August 19, 2014
BOARD OF COUNTY COMMISSIONERS
ORANGE COUNTY, FLORIDA

ADDENDUM NO. 7
IFB NO. Y14-748
ORANGE COUNTY EASTERN WATER RECLAMATION FACILITY
PHASE V AND CENTRIFUGE DEWATERING IMPROVEMENTS

ORANGE COUNTY UTILITIES DEPARTMENT
 EASTERN WATER RECLAMATION FACILITY
 PHASE V IMPROVEMENTS
EXISTING WRF SITE PLAN

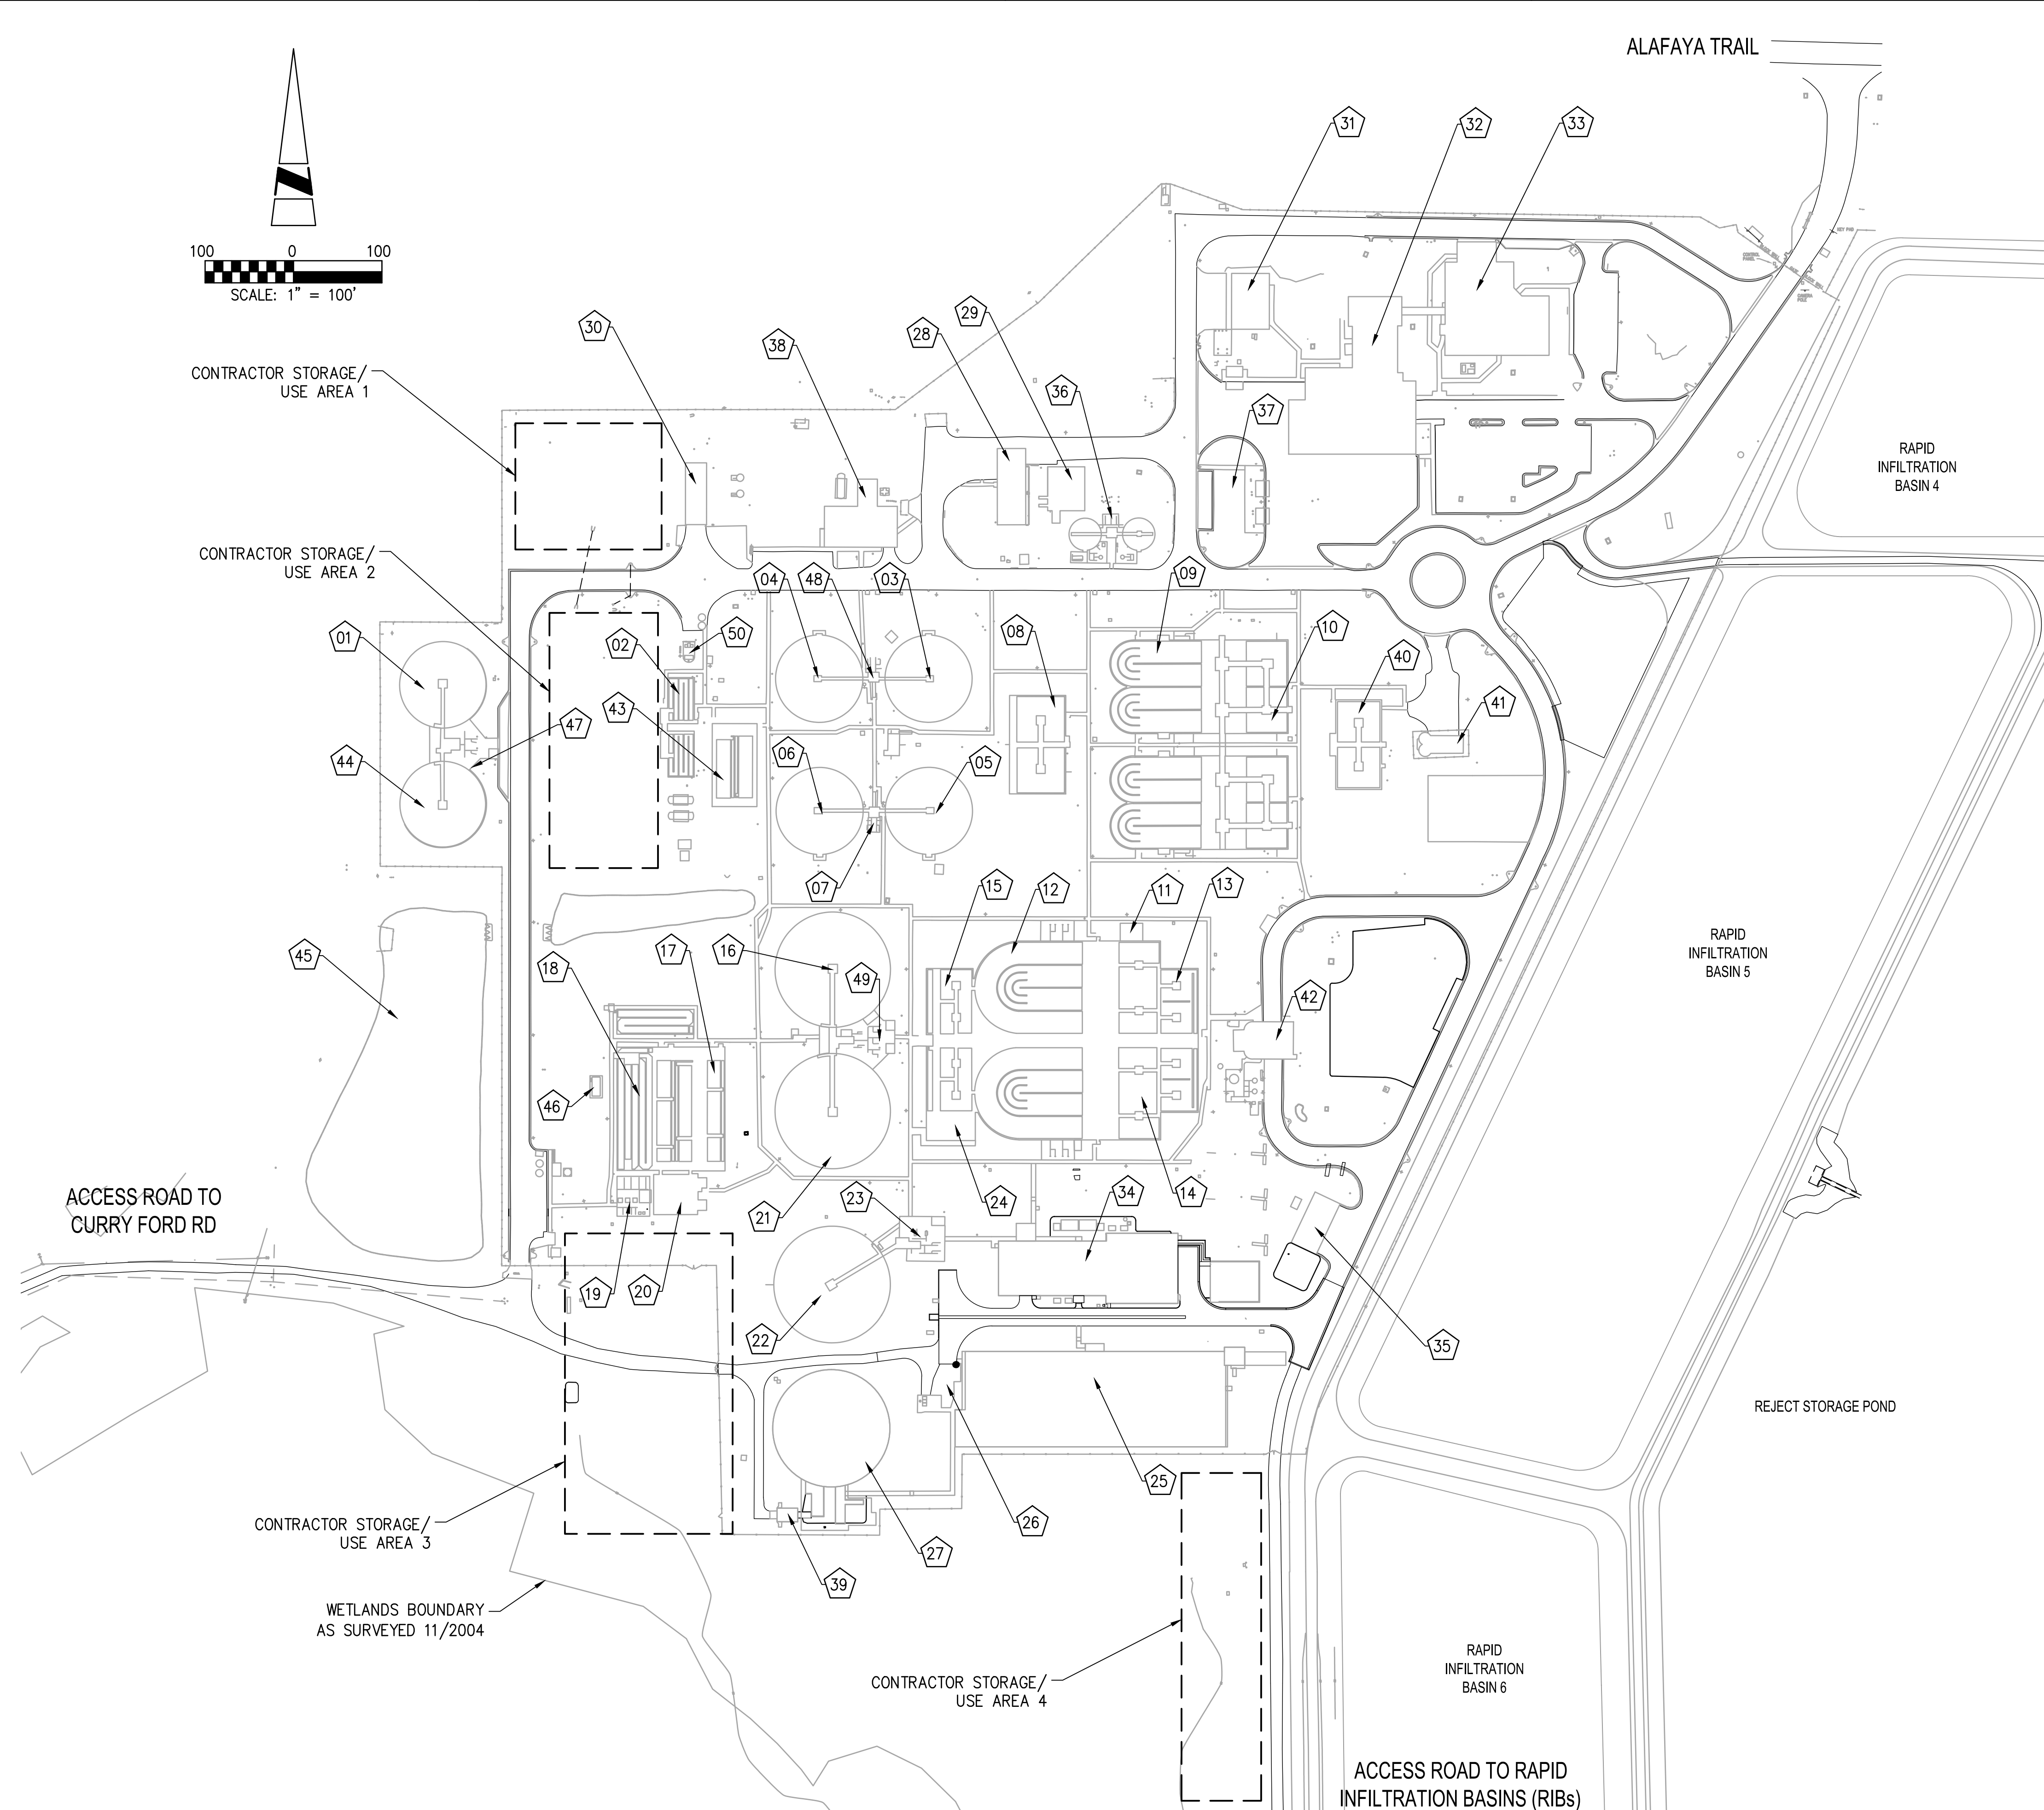
14. We assume that the storage location for salvaged equipment is located on site. Please confirm that there will be no offsite storage required. If offsite storage is required please provide the storage address.

There will be no offsite storage of salvaged equipment. All storage will be within the process facilities illustrated within Bid Package A, Drawing C-101, in a location as designated by the Orange County RPR

*Drawing C-101 is revised to illustrate the location of the Phase III In-Plant Lift Station (Process 395) it is in the northwest corner of the site. **(Attachment)***

WEIR PLATES AT DOWNSTREAM WEIR GATES

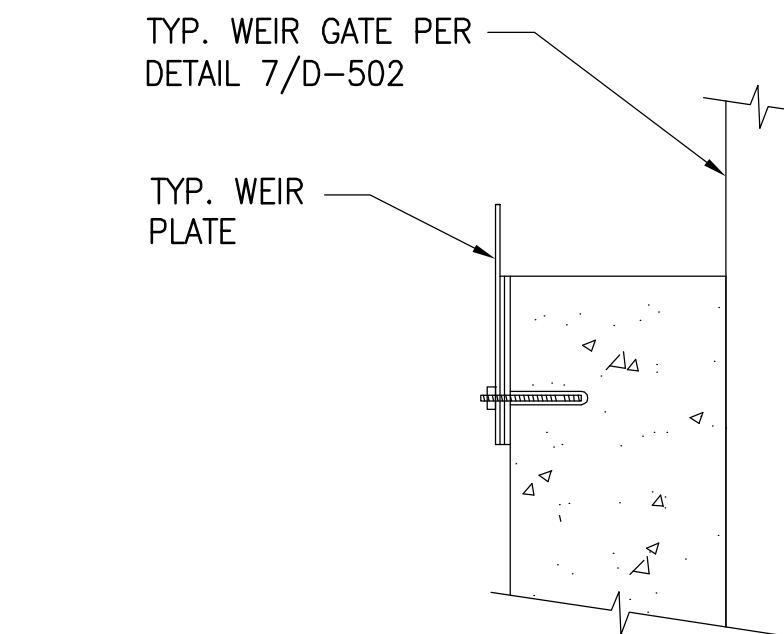
19. Bid Package A, Drawing S-500-504, Detail F shows Weir Plates at Downstream Weir Gates. I am unable to locate these Detail reference on the drawings in order to confirm the quantity and size. Please clarify.

Please reference Drawing S-500-304 and D-500-303. Detail F on Drawing S-500-304 is revised for clarity (Attachment)

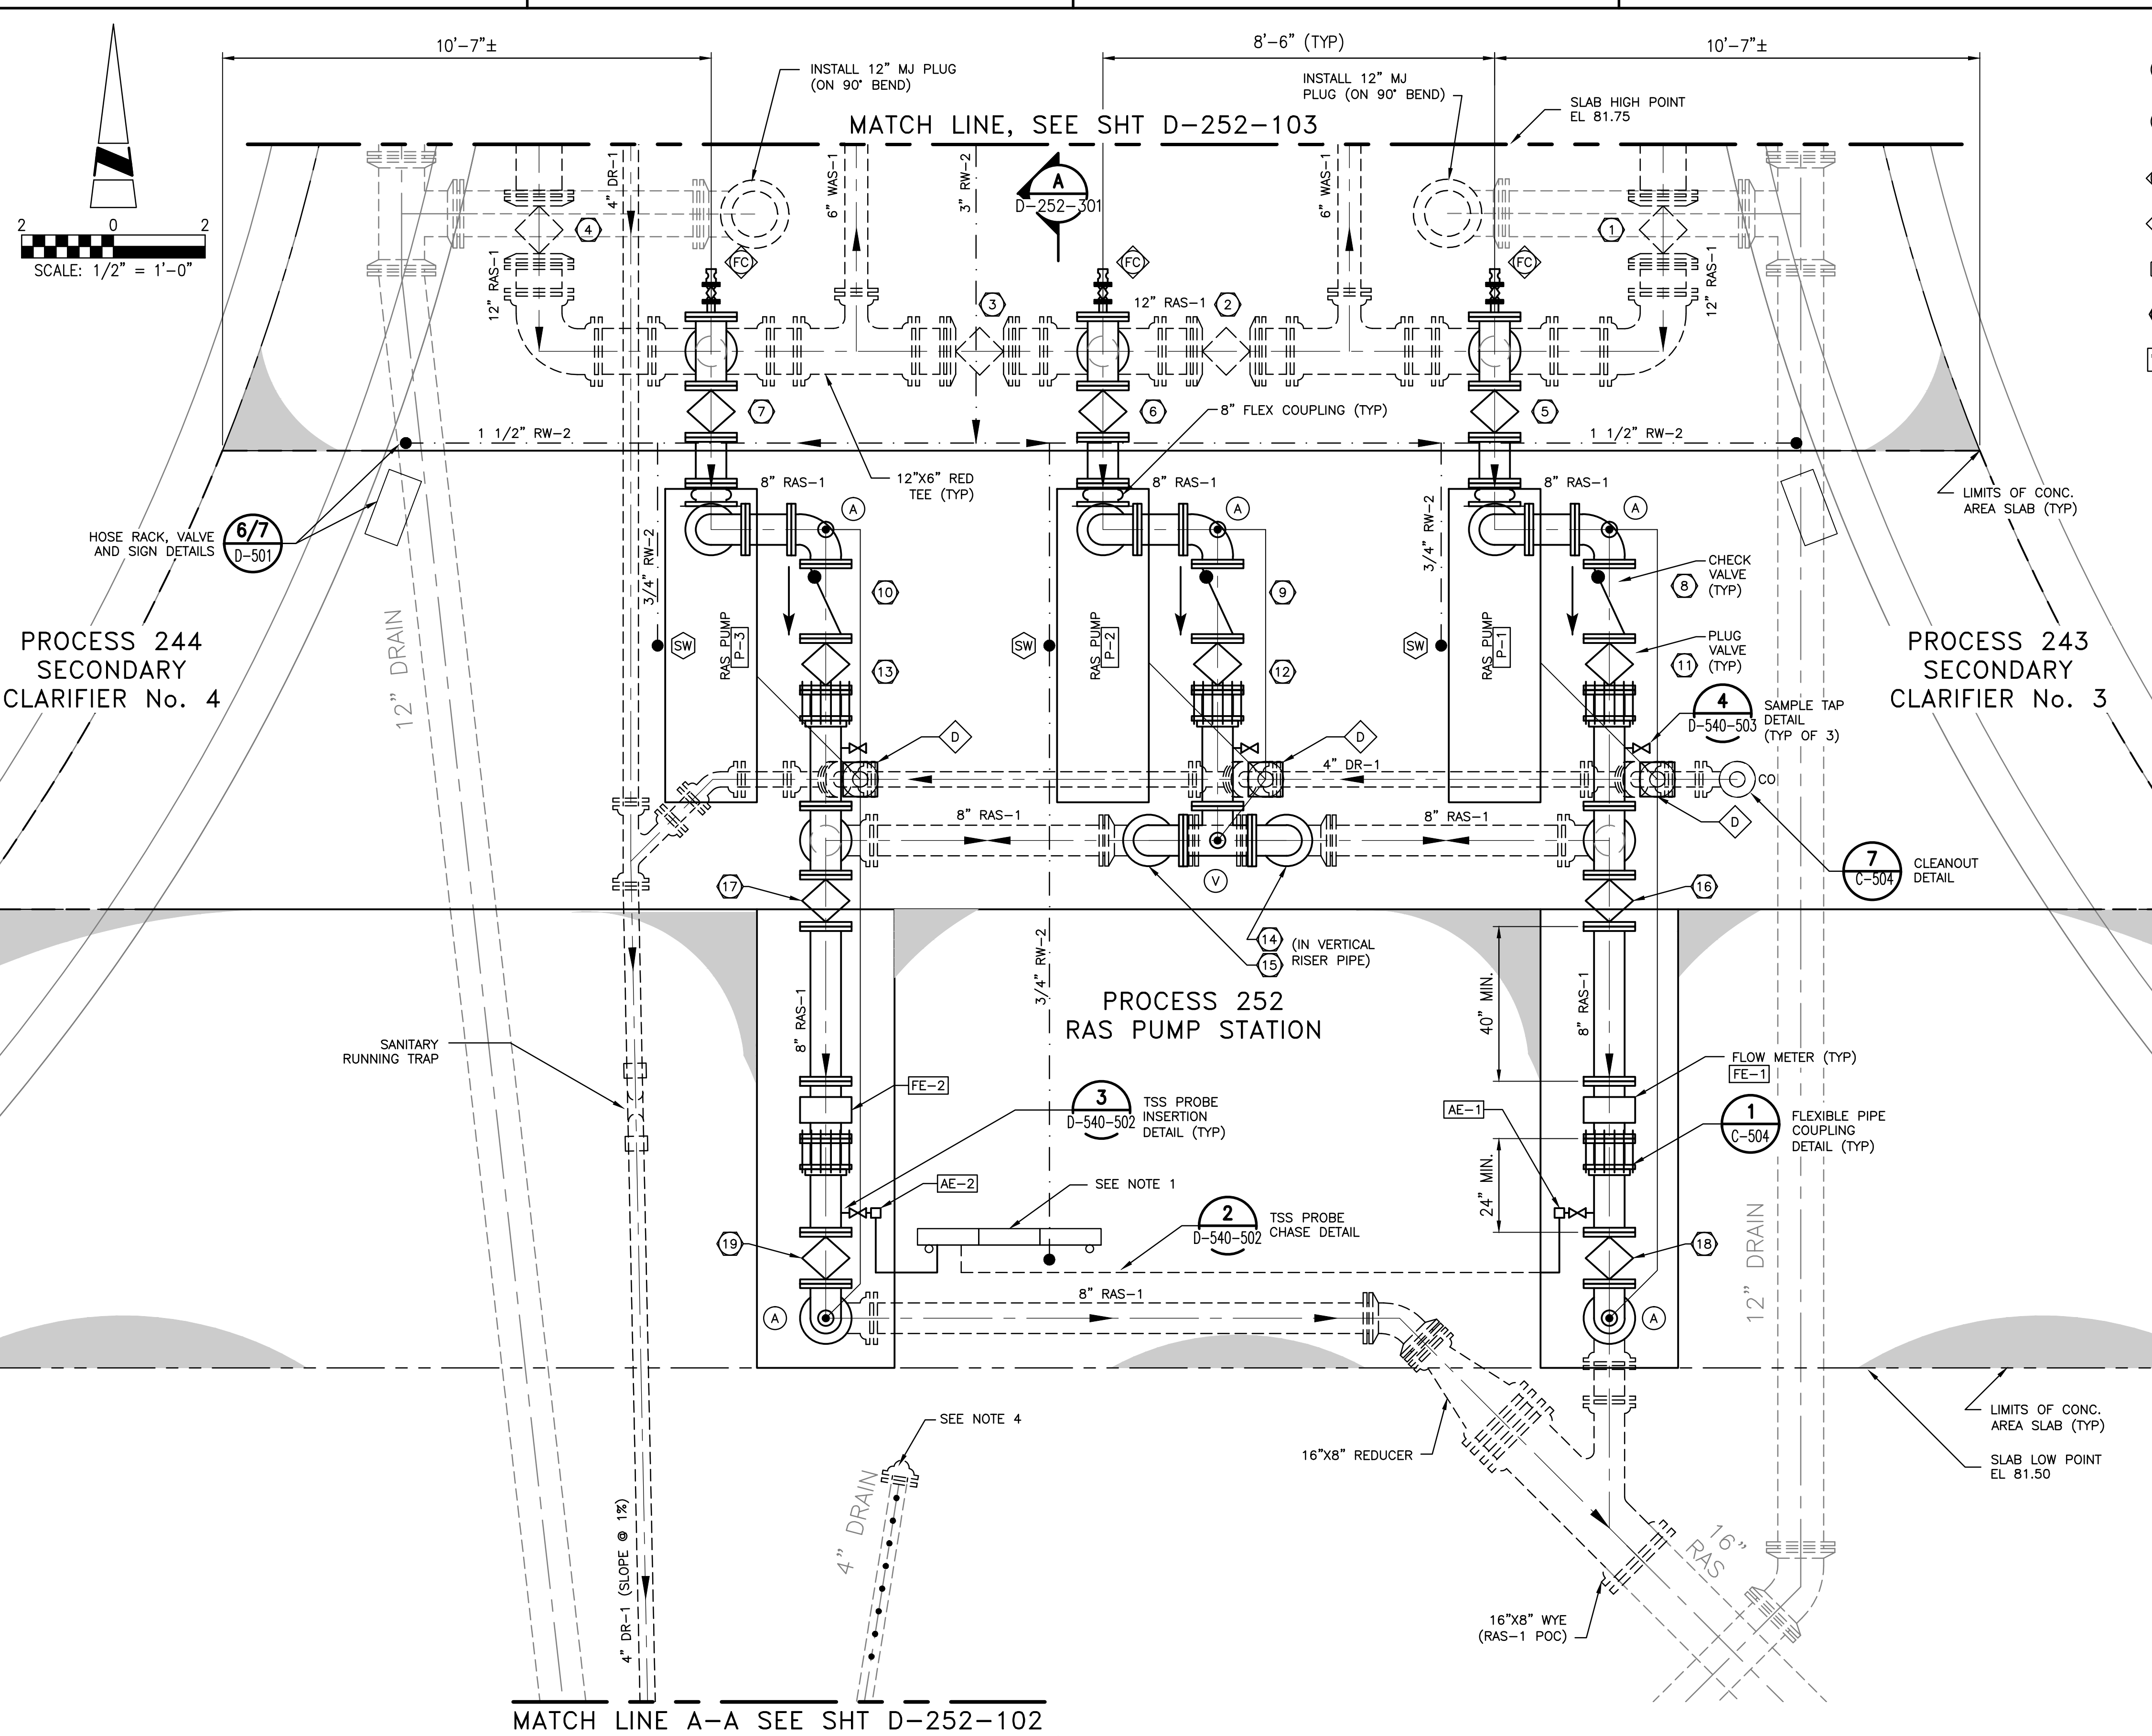
1. Reference the revisions at the Mixer in Process 231, on Drawing D-230-101. Operations relocated an existing Invent Mixer and installed it in this location. The existing Mixer is to be salvaged (**Attachment**).
